KATCHER RESIDENCE
3 COWDRAYS PARK DR. NORTH CASTLE, NY

SITE DEVELOPMENT PLAN
3 COWDRAY PARK DRIVE
 TOWN OF NORTH CASTLE, NEW YORK

Re: Response to Engineer Review Comments
Section 102.04, Block 1, Lot 24
3 Cowdray Park Drive, North Castle, NY

This letter is in response to engineering comments received by McChord Engineering Associates, Inc. in Memorandum prepared by Kellard Sessions Consulting, dated September 26, 2022. All responses are in reference to the attached documents prepared by this office, listed below.

SE1

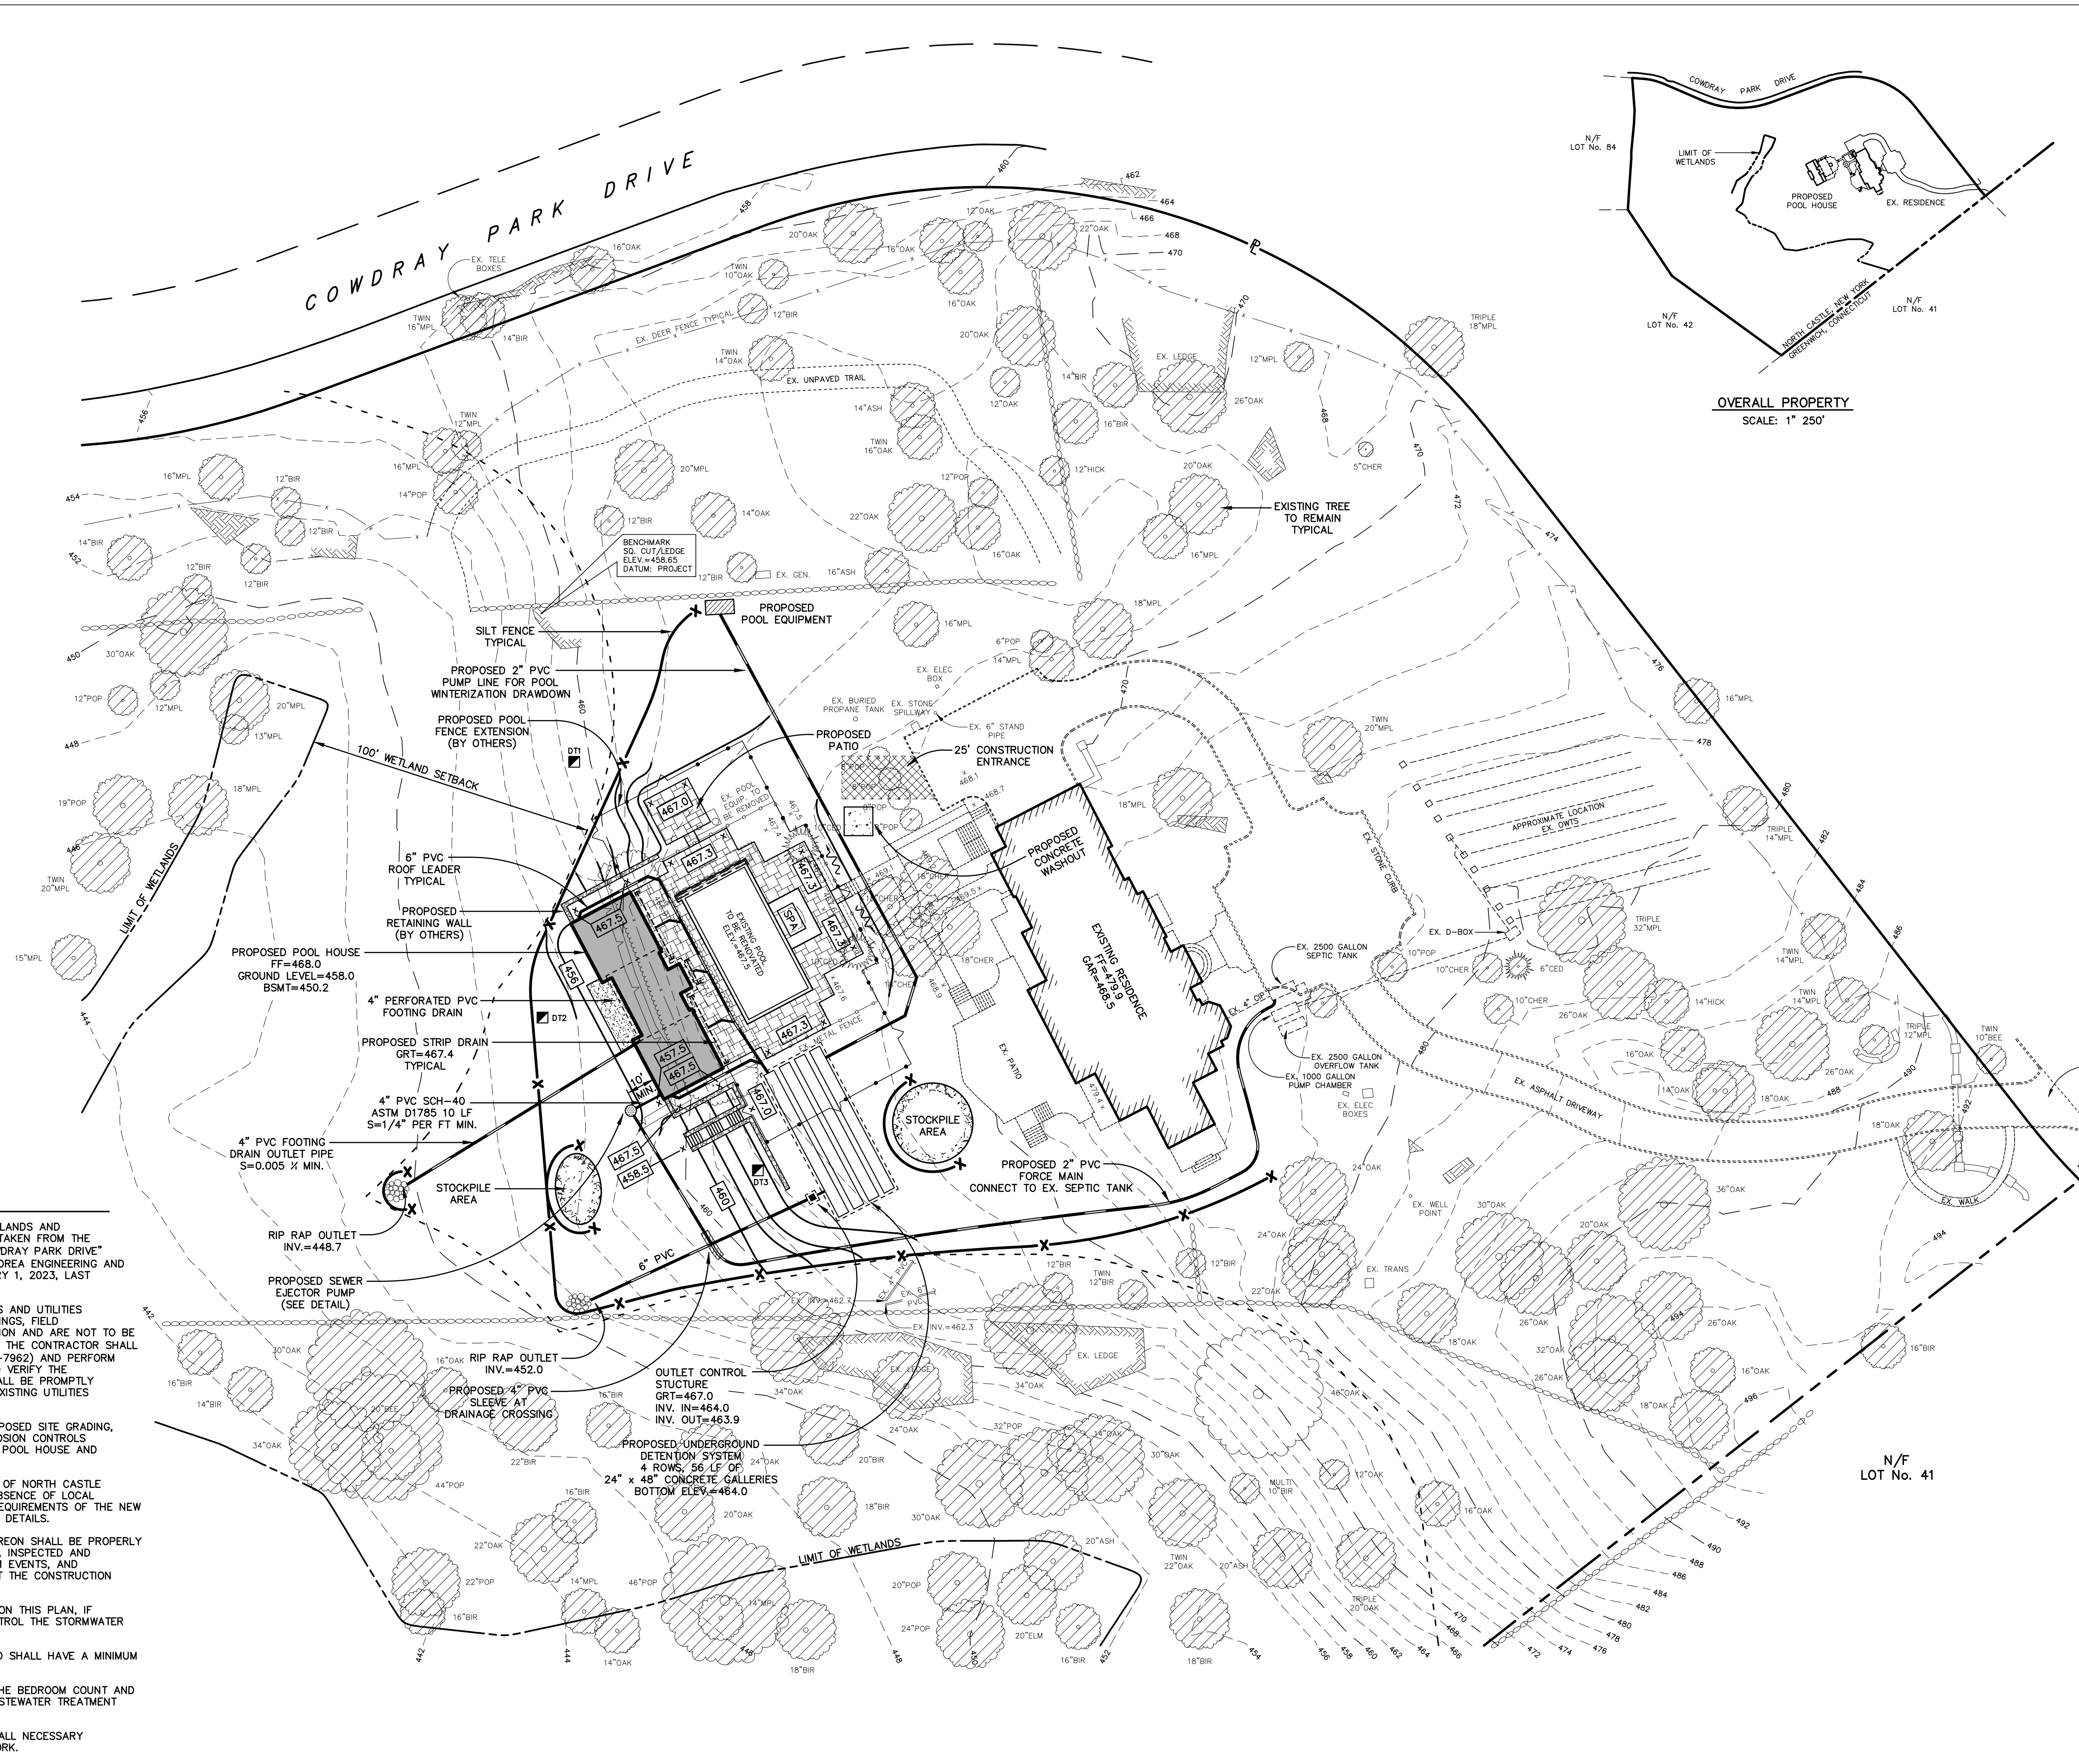
2. The application proposes an increase in impervious surface. The applicant should prepare a stormwater mitigation plan which mitigates runoff generated by the net increase in impervious surface for the 25-year, 24-hour rainfall event. The project plans should include details of the stormwater mitigation system.

3. The applicant shall perform deep and percolation soil testing in the vicinity of the proposed mitigation system to be witnessed by the Town Engineer. The test locations and results shall be shown on the plan. Contact this office to schedule the testing.

4. The project plans should include existing stormwater collection piping and mitigation systems servicing the existing pool, residence and driveway.

5. The applicant is proposing the reconstruction of the existing pool terrace. The project plans should include the existing stormwater collection system for the existing terrace. If collection facilities do not exist, the applicant should show include terrace drains within the design.

7. The Site Plan includes proposed grading within the rear of the proposed pool house. The project grading should be expanded to illustrate the proposed grade of the reconstructed pool terrace. Please also include upper and lower floor elevations of the proposed pool house.

9. The project stormwater mitigation system should include an erosion and sediment control plan which mitigates impacts during construction. Please include erosion and sediment control details.

10. Please provide construction details of all proposed site and drainage improvements.

Response – *The Site Development Plan shows stormwater management measures to mitigate impacts from the increase in impervious area for storm events up to a 25-year storm. Refer to the Stormwater Management Report for additional information.*

Response – *Deep soil tests were performed and witnessed by Kellard Sessions personnel. Testing results are shown on the Site Development Plan. Percolation tests were not performed as infiltration would not be allowed in the design of the detention system due to the soil conditions.*

Response – *There are no existing stormwater collection or mitigation systems on site. There is a roof leader discharge pipe for the residence and it is shown on the Site Development Plan.*

Response – *There are no stormwater collection system for the existing pool terrace. A slot drain is shown on the Site Development Plan to collect runoff from the proposed pool terrace between the pool and new pool house. The remainder of the pool terrace will sheet flow to the lawn conforming to existing conditions.*

Response – *All proposed grading is shown on the Site Development Plan. Pool house elevations are included in the architectural drawing set.*

Response – *The Site Development Plan includes erosion and sediment controls and details.*

Response – *The Site Development Plan includes construction details for site and drainage improvements.*
